Final Safety Evaluation Report for the Combined License for Enrico Fermi 3

Docket Number 52-033

DTE Electric Company

Chapters 1 to 9

Figure 2.4.3-1. Hourly Distribution of the Probable Maximum Precipitation for the Swan Creek Watershed

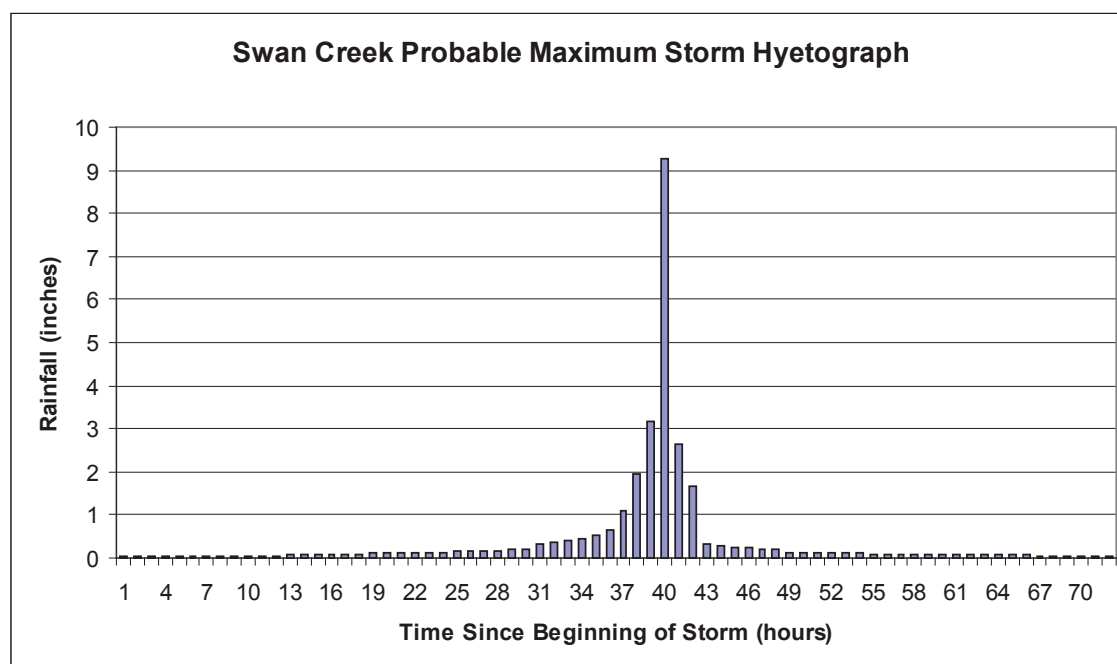
The applicant's input and output values for the HMR-52 program were very similar to the staff's. Both the staff and the applicant used a value of 0.302 for the ratio of the 1 to 6 hour storm. The staff found a maximum storm orientation of 309 degrees and the applicant found a maximum storm orientation of 311 degrees. The depth-area-duration curves used by the applicant were slightly larger overall than those used by the staff, and thus the applicant's analysis was more conservative. Therefore, the applicant's input values were found to be acceptable. The applicant calculated a PMP of 28.9 from the HMR-52 software, the same value determined by the staff's calculation.

The staff-calculated PMP with snowmelt for the Swan Creek Watershed shown in Figure 2.4.3-1 above can be directly compared to Figure 2.4-XX-3 submitted by the applicant with the response to RAI 2.4.2-1, dated September 30, 2009 (ADAMS Accession No. ML092790561). The staff finds the applicant's calculation of PMP with snowmelt to be acceptable, because the applicant's PMP is the same as the value calculated by the staff.

Figure 2.4.3-3. Probable Maximum Flood Runoff using HEC-HMS 3.1.0 Rainfall-runoff Model

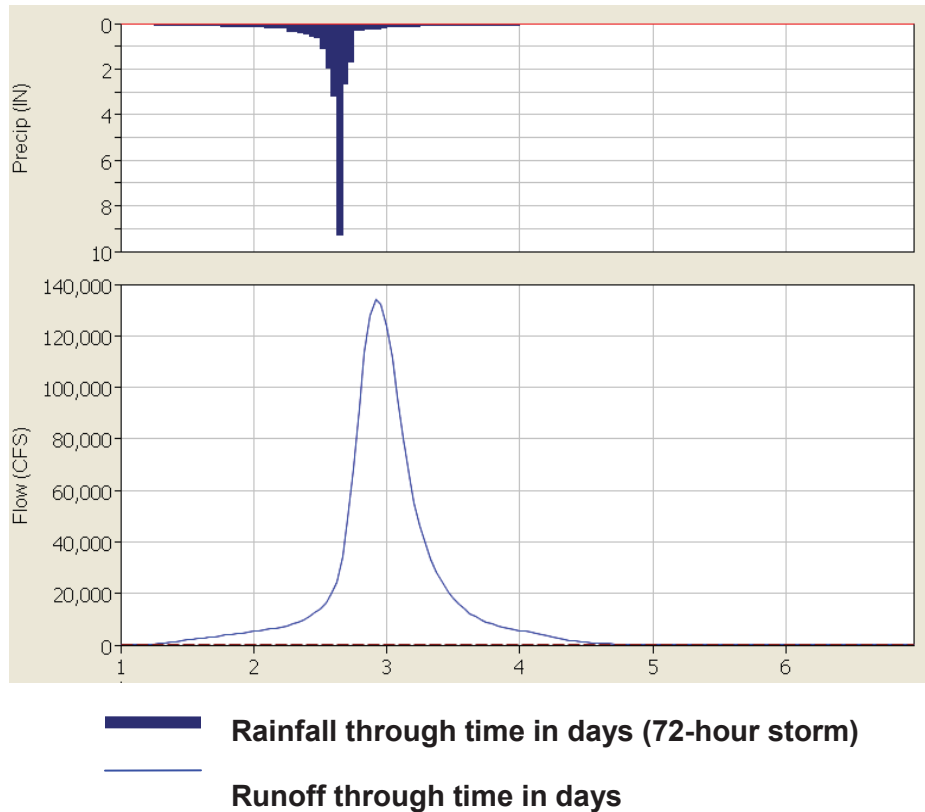
In Figure 2.4.3-3, the staff developed flood hydrographs based on the parameters discussed above. By developing an independent hydrograph, Figure 2.4.3-3 can be directly compared with Figure 2.4-219 of the FSAR to examine the PMF runoff calculated by the staff versus the PMF runoff calculated by the applicant.

Figure 2.4.3-4. Probable Maximum Flood with Snowmelt Runoff using HEC-HMS 3.1.0 Rainfall-Runoff Model

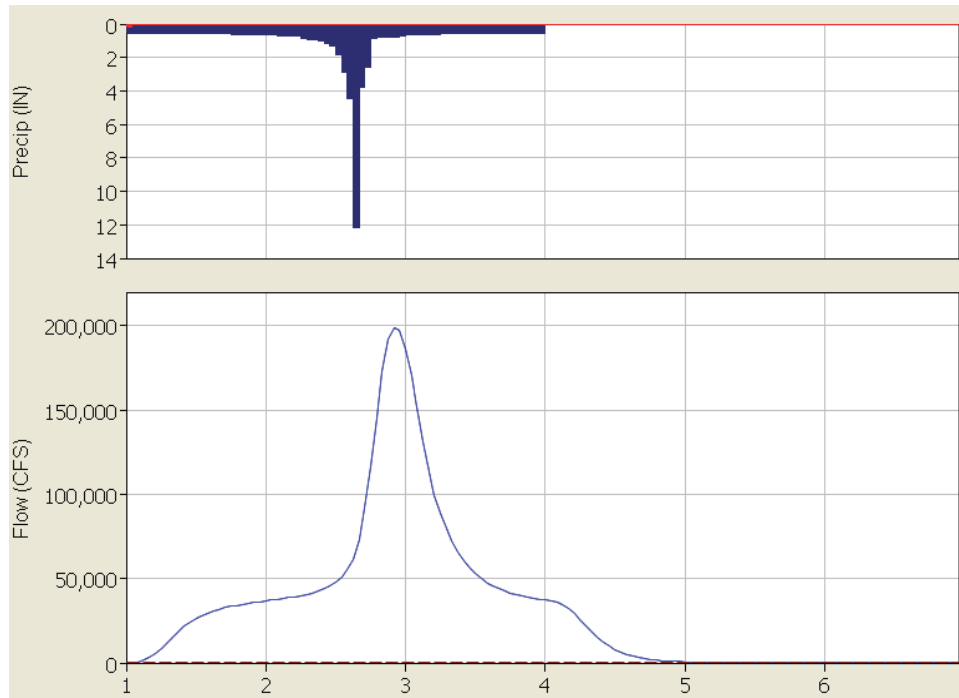
In Figure 2.4.3-4, the staff independently developed a flood hydrograph that include snowmelt. The staff hydrograph in Figure 2.4.3-4 can be directly compared with Figure 2.4-2-XX-4 of the response to RAI 2.4.2-1, dated September 30, 2009 (ADAMS Accession No. ML092790561) to examine the runoff from the PMF plus snowmelt calculated by the staff versus the PMF plus snowmelt runoff calculated by the applicant.

Figure 2.5.1-5 Photographs of Strata in the Denniston Quarry, Monroe, Michigan.
 Note: A. Exposure of paleokarst feature in the Bass Islands Group and disrupted bedding beneath the feature.
 B. Insert of disrupted bedding beneath paleokarst feature.]

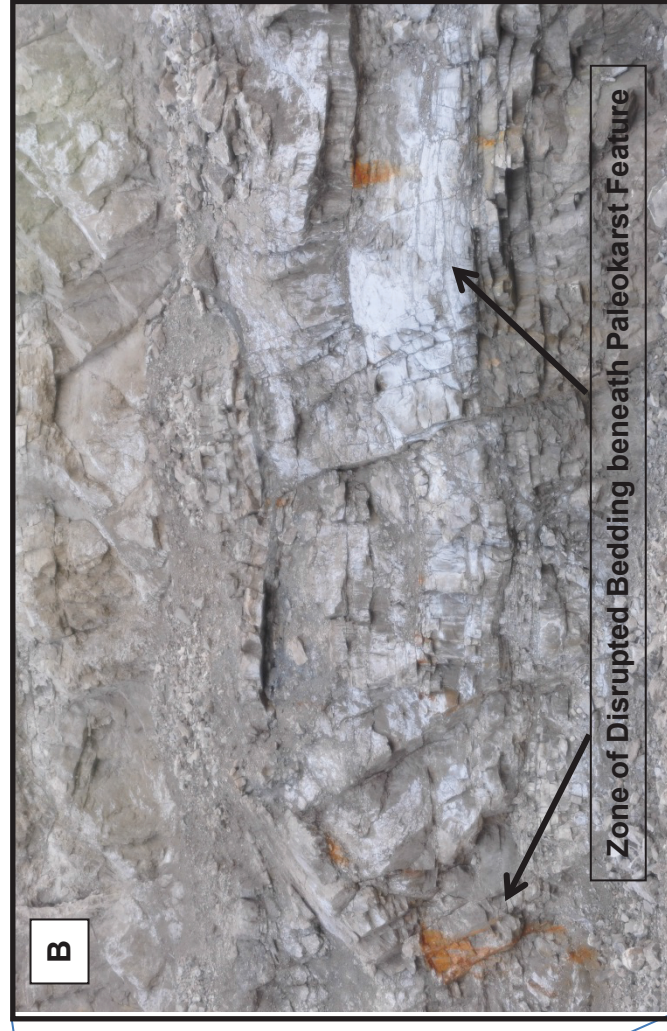
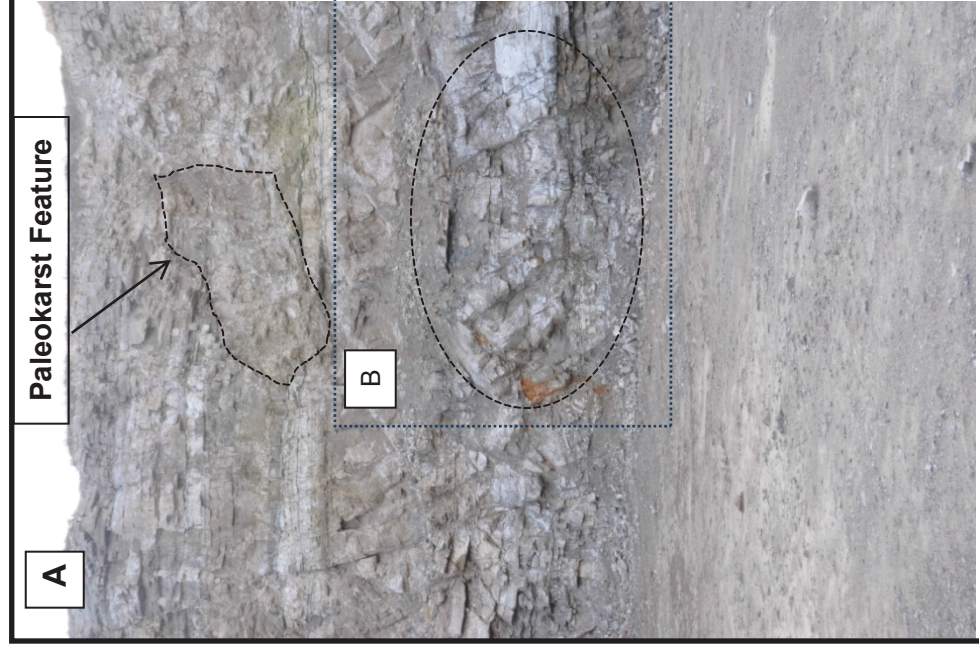
During the NRC staff's visit to the Denniston Quarry in Monroe County, Michigan, as part of a November 2009 Fermi 3 COL site audit, the staff noted at least three zones of disrupted bedding exposed in the quarry walls. These disrupted zones suggest possible faulting of the Bass Islands Group. In one location, disrupted bedding exists beneath an interpreted paleokarst feature (located near the top of the geologic section) and suggests that the paleokarst development may be associated with faulting at depth. Figure 2.5.1-5 in this SER shows this paleokarst feature above a zone of disrupted bedding in the Bass Islands Group. In a second quarry location, a zone of disrupted bedding exists with mostly undisturbed bedding on either side. This second zone appears to be at least seven to ten meters wide; contains disrupted bedding from the top to the bottom of the exposed wall; and is flanked by relatively undisturbed bedding on both sides. The third zone of possible disturbed bedding was visible in a distant wall and could be related to vertical offsets within the Bass Islands Group.

Figure 2.5.2-9 Plot Comparing the Staff's and the Applicant's 1-Hz Total Mean Hazard Curves for the Distributed Seismicity Source Zones

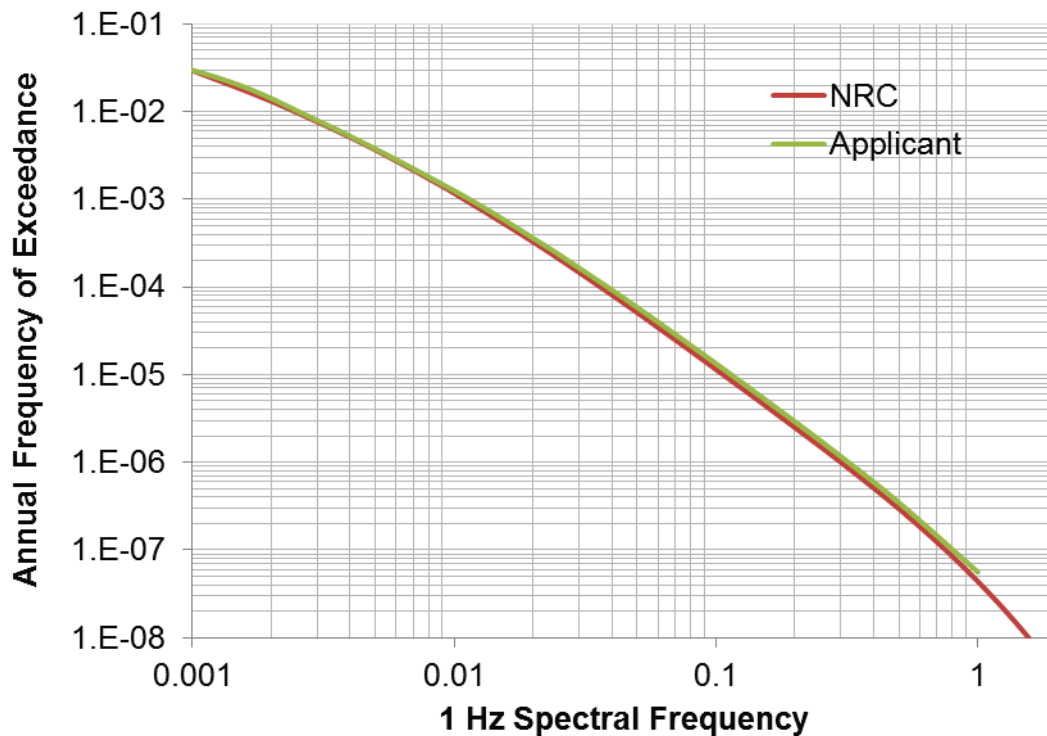
To determine the adequacy of the applicant's PSHA calculations, the staff performed its own confirmatory PSHA calculation for the Fermi 3 site. The staff used the CEUS-SSC model (NUREG-2115) along with the EPRI (2004, 2006) GMM. The staff conducted the PSHA for the Fermi site using a source distance radius of 1,000 km (620 mi) for the CEUS-SSC-distributed seismicity sources. The staff's calculation did not include the RLME source zones. Therefore, the staff compared its confirmatory 0.5, 1, 2.5, 5, 10, 25, and 100 Hz hazard curve results with the applicant's results for the distributed seismicity sources and determined that the two sets of results are almost identical. This finding is illustrated in Figures 2.5.2-9 through Figure 2.5.2-11 in this SER showing the PSHA hard rock hazard curve results for 1, 10, and 100 Hz, respectively, for the distributed seismicity sources.

Based on the above assessment, the staff concluded that the applicant's PSHA calculations adequately characterize the seismic hazard at the Fermi 3 site in terms of the contribution from the distributed seismicity sources. Because the staff's calculation did not include the RLMEs, the staff determined that the applicant had selected the appropriate RLME sources (i.e., the NMFS, WA, CHV, and CHS) based on their contribution of 1 percent or greater to the total mean hazard.

Figure 2.5.2-12 Comparisons of the Staff's Site Response Amplification Functions with the Amplification Functions Determined by the Applicant

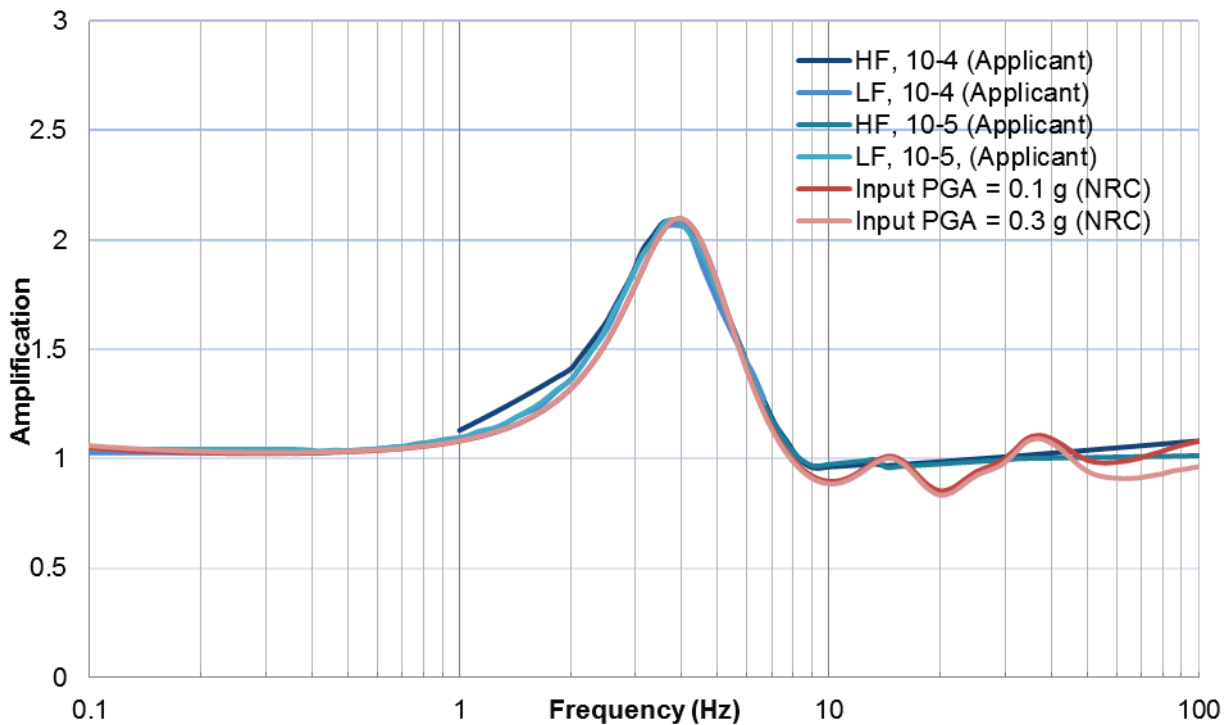
To determine the adequacy of the applicant's site response calculations, the staff performed confirmatory site response calculations. As input, the staff used the static and dynamic soil properties in FSAR Section 2.5.4 and summarized in FSAR Table 2.5.2-213. The staff performed site response calculations using the RVT methodology with 7 spectral frequencies and 11 input rock amplitudes. The use of RVT in site response calculations is mentioned in RG 1.208 as an acceptable alternative to the time series approach. The staff's site amplification function results are compared with the applicant's results in Figure 2.5.2-12 in this SER.

Based on the above assessment, the staff concludes that the applicant's site response calculations adequately characterize the Fermi 3 site effects.
